**PLANNING DIRECTOR'S SPECIAL PERMIT
FOR SINGLE FAMILY RESIDENTIAL IN A PUD**

FILE: P00-121

PROJECT NAME: Northborough Village 3-2

Exhibit 1 | Site Plan

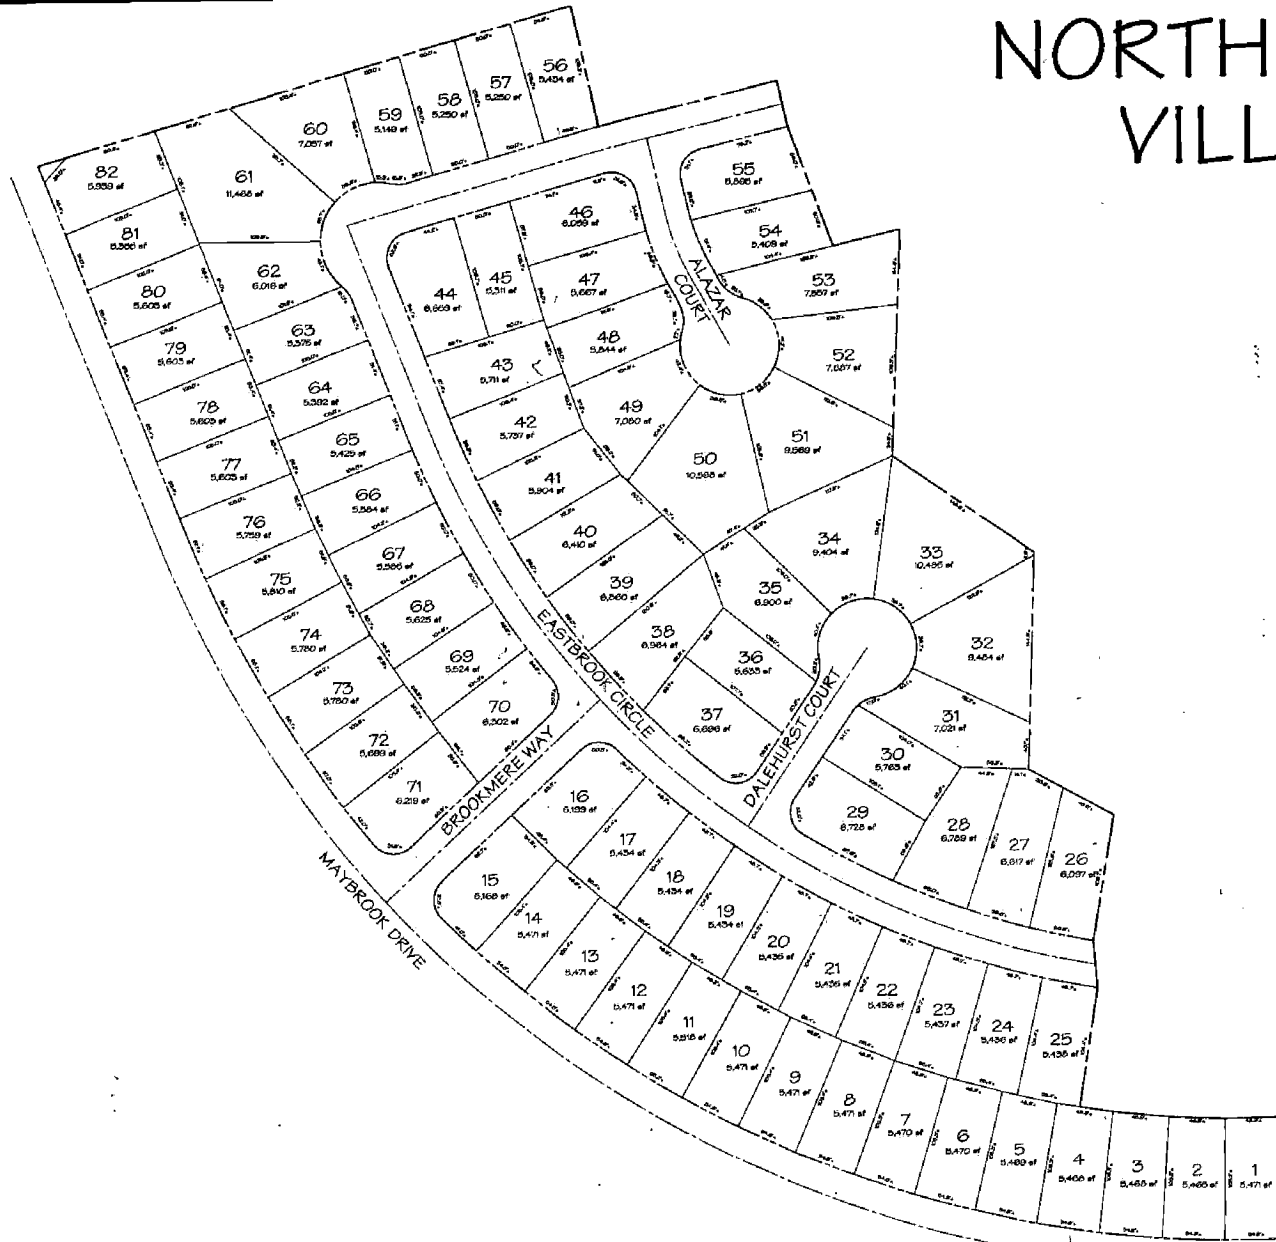
Corner Lots: There are nine corner lots in Northborough Village 3-2 (see Exhibit 1). As indicated earlier, Plan 1760 will be restricted to corner lots only, while Plan 2546 will not be allowed on corner lots. On corner lots, the driveway must be located away from the corner. All of the other house plans are acceptable on corner lots, as long as setback and lot coverage requirements are met.

- i. Roofing shall be concrete tile; the roof shall be finished with end and ridge caps; and roof pitch shall be no less than a 5 to 12 pitch;
- j. On corner lots, the driveway shall be located away from the intersection of streets; and

Exhibit 2 (b) - elevations

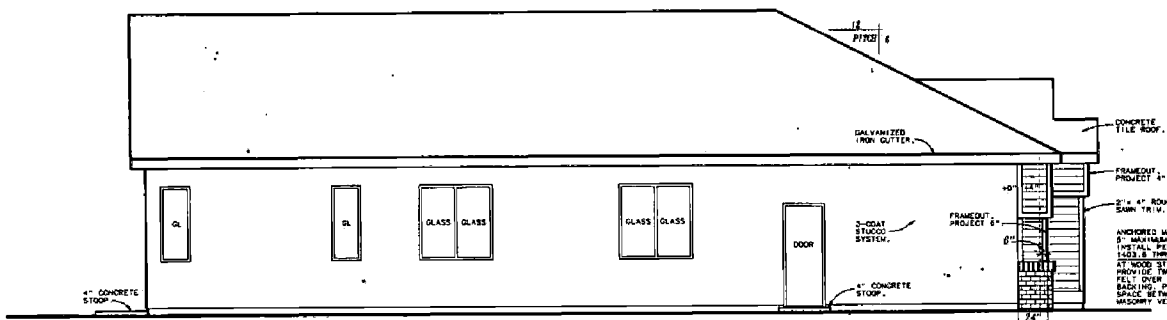
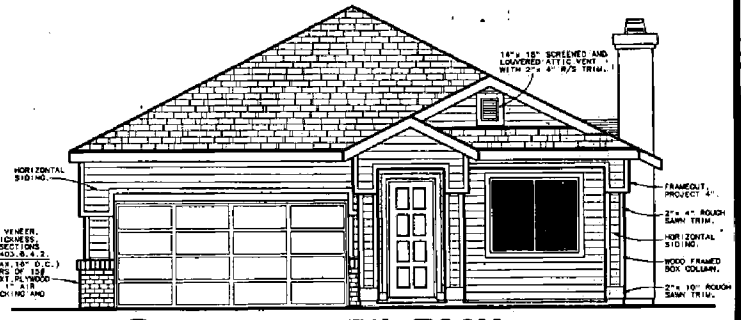
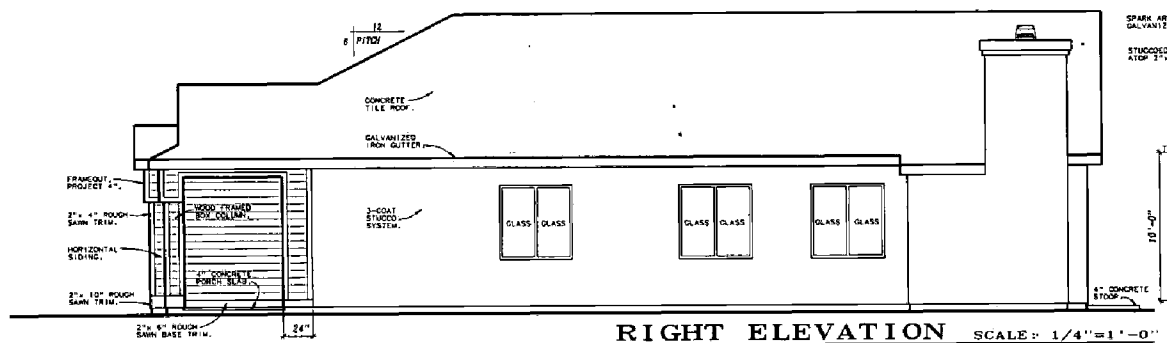
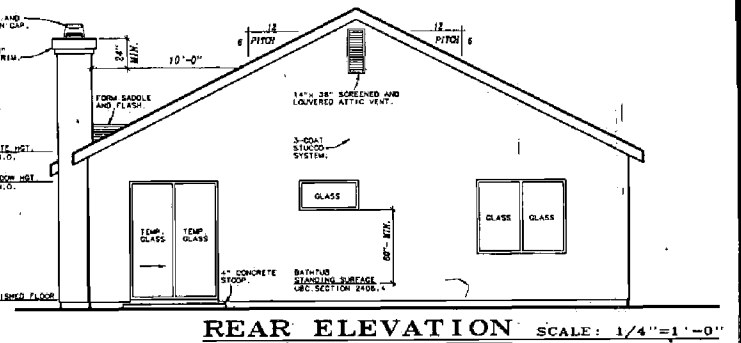
As shown in Table 3 below, the new single-story Plan 2072 will not fit on the typical lot with respect to lot coverage, even with allowance for the front porch. Minimum lot area to provide the maximum allowed 45 percent lot coverage for this plan is 5,487 square feet, and this takes into consideration the allowance for all front porch area. There are a total of 32 lots less than 5,487 square feet in the subdivision, while all other lots (a total of 50) are large enough for Plan 2072 with respect to lot coverage. Staff is not concerned

- g. A porch railing option shall be offered on all those plans that provide a usable porch; specifically, the new Plans 1725, 1857, and 2072, and previously approved Plans 2129 and 2301; and these porch treatments shall be coordinated with the architecture of the respective elevations, subject to review and approval by Planning staff prior to the issuance of building permits;

Exhibit 4 (c) - elevations

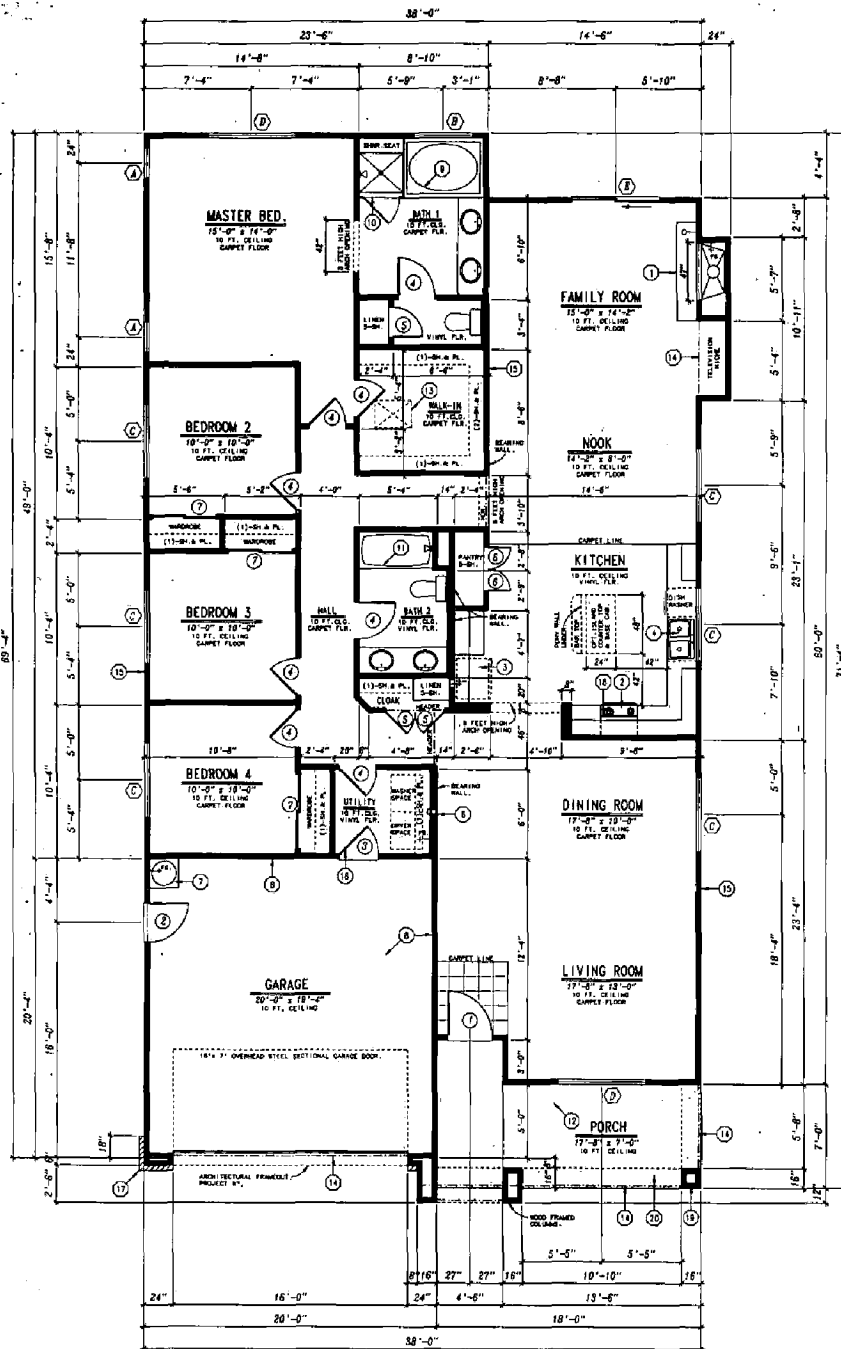
There are some lots in the subdivision that are slightly less than 105 feet in depth; however, only Plan 2072 will be restricted by a lot depth of less than 105 feet. This restriction will limit Plan 2072 from an additional nine lots, in addition to those lots without sufficient area to meet lot coverage requirements. In addition, some of the lots are slightly tapered, from narrower than 50 feet at one end to wider than 50 feet at the other; however, if any of these lots are too narrow to accommodate the 40 foot wide plans, they will certainly be wide enough to accommodate one or more of the variants of the new house plan, which are less than 40 feet wide. Otherwise, more than one of the house plans submitted will fit on any lot in the subdivision with respect to setbacks.

- a. **Plan 1760** shall be allowed only on corner lots;
- b. **Plan 2546** shall be allowed only on interior lots;
- c. **Plan 2072** shall require a minimum lot size of 5,487 square feet to remain within the maximum lot coverage of 45% allowed in Northborough PUD for a single-story house plan;
